Staff Report

Re: Petition PLNHLC2019-00860, Masonic Temple Apartments (Regius Flats)

NEW CONSTRUCTION IN A HISTORIC DISTRICT

WEST STREETSCAPE PHOTOMONTAGE
NTS

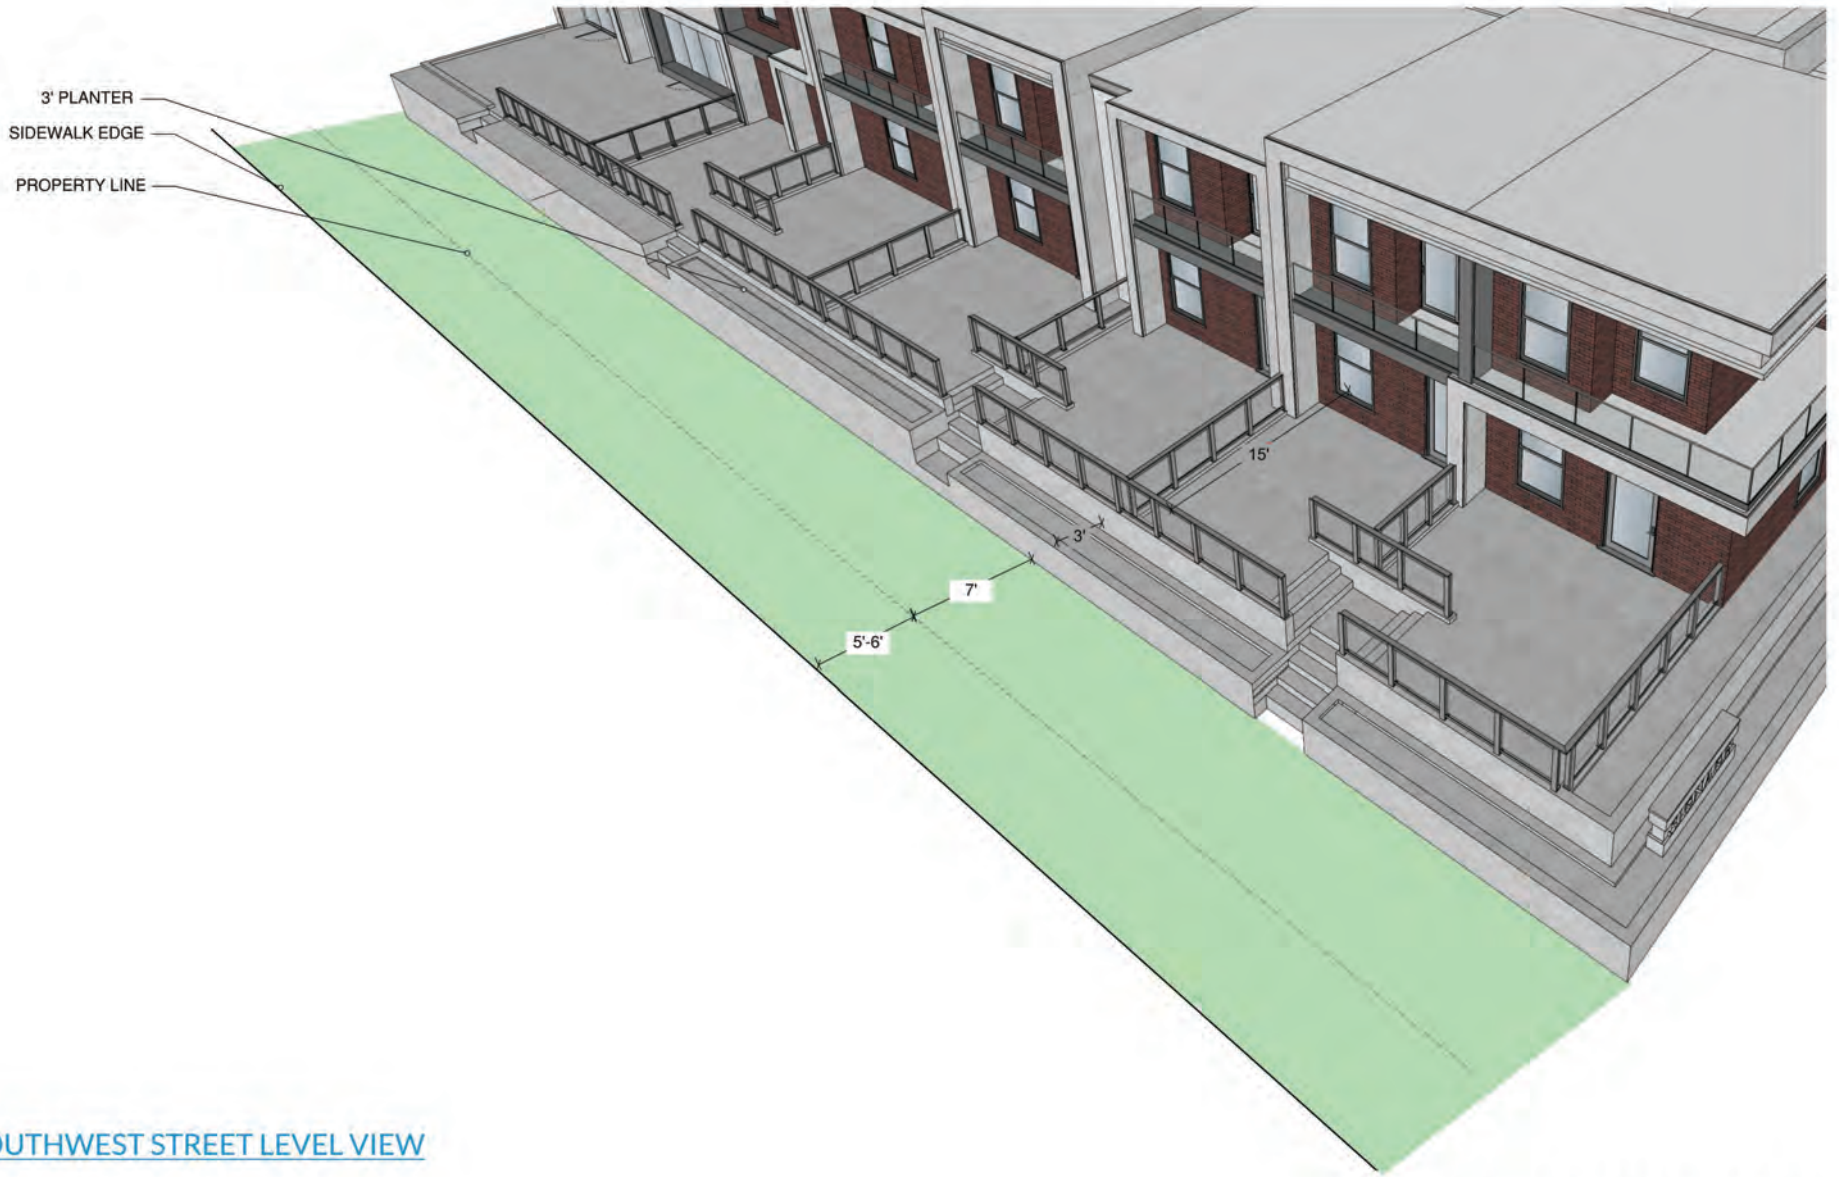
Chairperson Kenton Peters asked for a street scape on the west elevation to show the commission how this project relates to neighboring properties.

TREE PLANTING PLAN

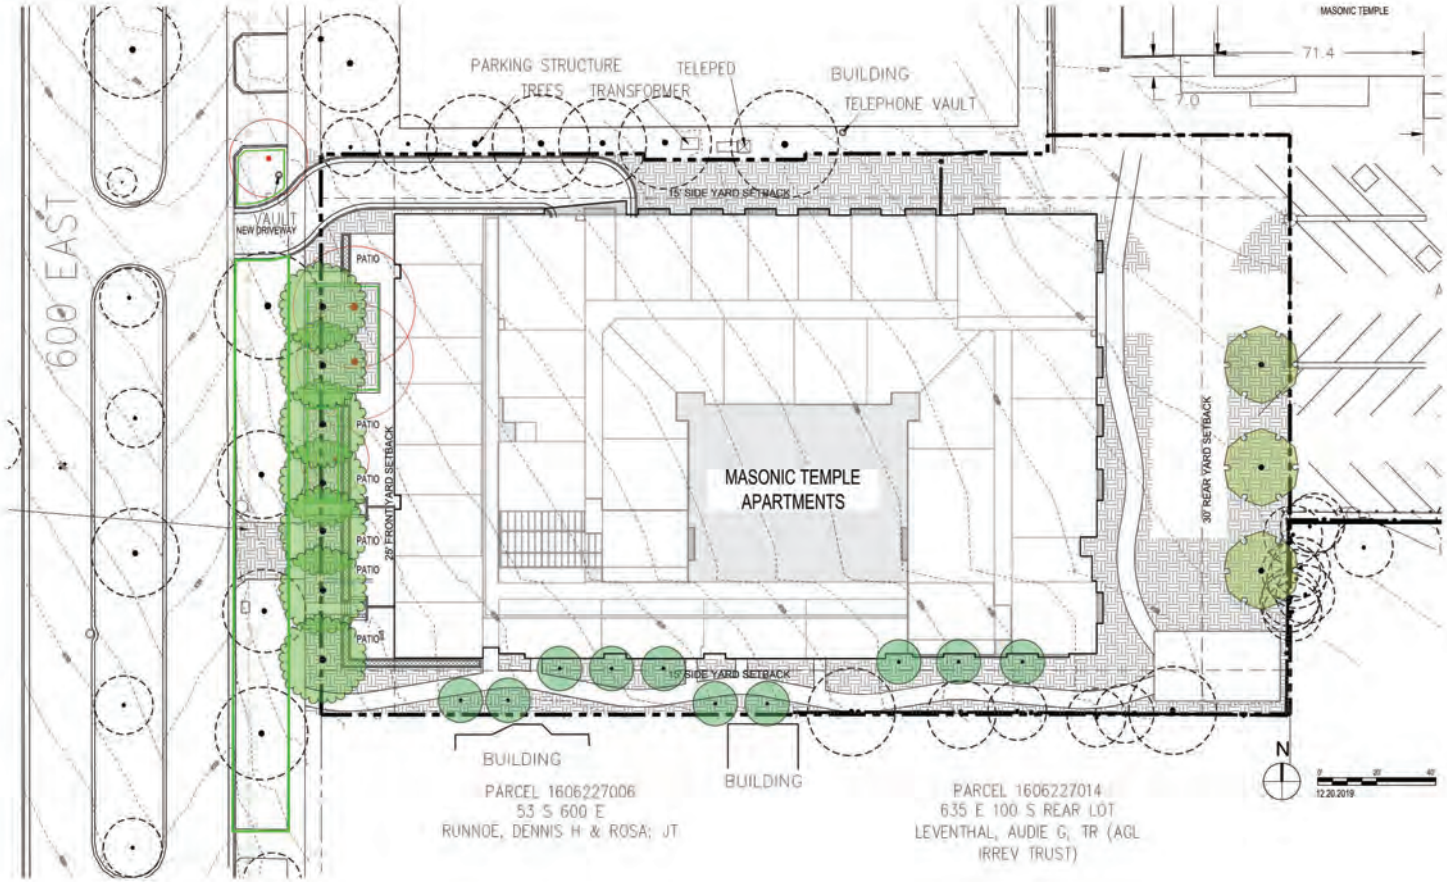
Commissioner Richardson discussed the trees on the 600 East and asked for plans to protect them, a mitigation plan if needed, and asked for further explanation on the set back on 600 East and asked about how high the grading is. Architect Meghnad Aubry discussed the yards starting at grade and moving up to being about 5 feet tall, and there is about a 15-foot set back from the sidewalk.
